HISTORIC PRESERVATION REVIEW BOARD STAFF REPORT AND RECOMMENDATION

X Agenda Property Address: 1201-1219 Massachusetts Ave NW

Landmark/District: Church of the Ascension and St. Agnes

X Alteration H.P.A. Number: 23-367

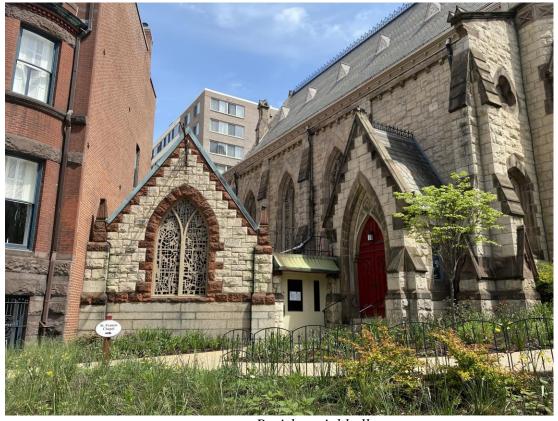
While somewhat different than the shorter option previously presented, the revised massing and the sloped roof of the parish hall addition relate well to the sloped roof of the church. The addition achieves compatibility through its simple deferential shapes, clear glass skin, and recessed placement back from the street. The use of masonry and refinements to the proportions of the windows in the residential tower also improve that component's compatibility.

HPO recommends that the Board find the revised design to be compatible with the landmark and the Shaw Historic District, and to delegate final approval to staff.
